## Evaluation of proposed move for Water Right No. 23955

Proposed: Move water right no. 23955 a distance of 1,214 ft to the east onto a new location.

WELL TEST ANALYSIS

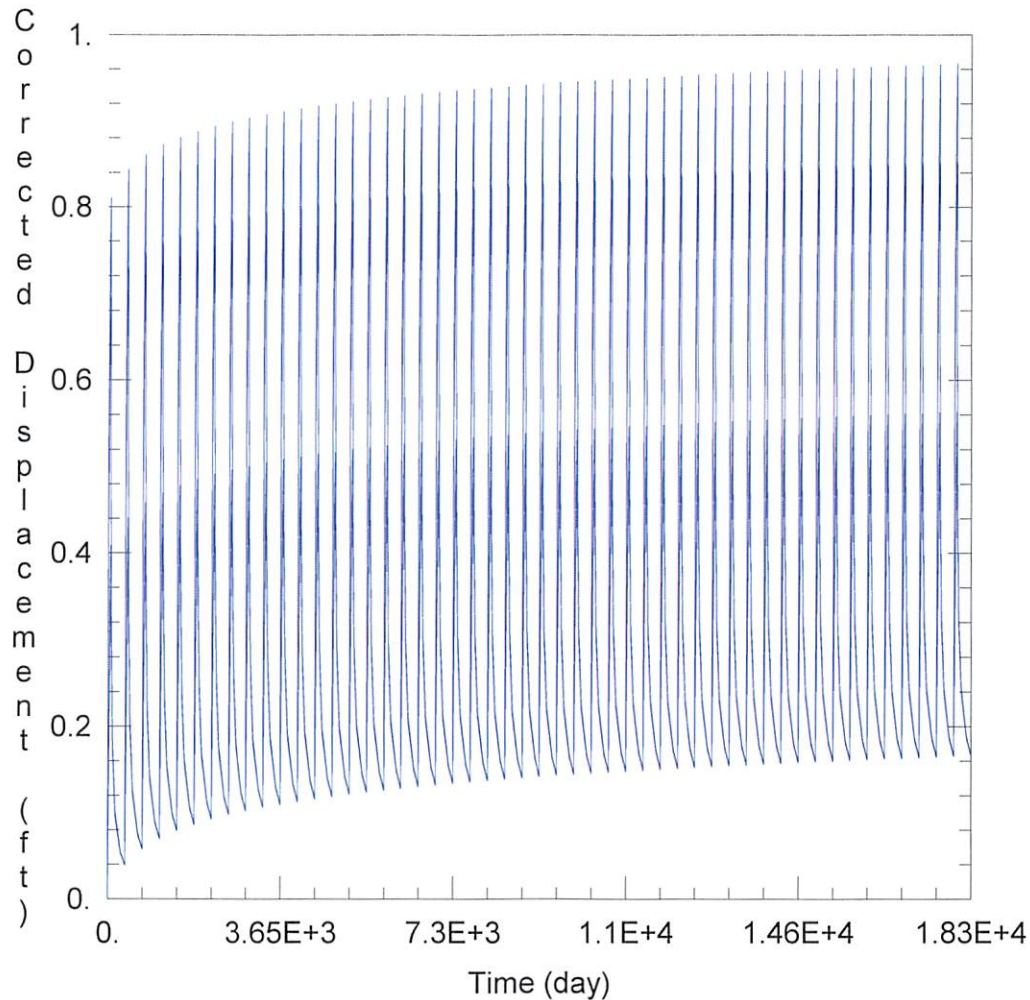
462: Drawdown from current location = 0.23 ft  
Drawdown from proposed location = 1.43 ft  
Net drawdown = **1.2 ft**

18253: Drawdown from current location = 1.02 ft  
Drawdown from proposed location = 1.81 ft  
Net drawdown = **0.8 ft**

20044: Drawdown from current location = 0.65 ft  
Drawdown from proposed location = 2.32 ft  
Net drawdown = **1.7 ft**

24487: Drawdown from current location = 0.63 ft  
Drawdown from proposed location = 1.86 ft  
Net drawdown = **1.2 ft**

7388: Drawdown from current location = 0.23 ft  
Drawdown from proposed location = 1.66 ft  
Net drawdown = **1.4 ft**

17395: Drawdown from current location = 0.20 ft  
Drawdown from proposed location = 1.39 ft  
Net drawdown = **1.2 ft**

Net drawdown does not exceed the drawdown allowance of 3.5 ft for any well within 1 mile of the proposed location. Therefore, critical well analysis is not necessary.

The proposed move is likely to create minimal effects on neighboring wells and appears unlikely to cause impairment. Any concerned neighbors should contact GMD3 at (620) 275-7147 or the Division of Water Resources at (620) 276-2901.
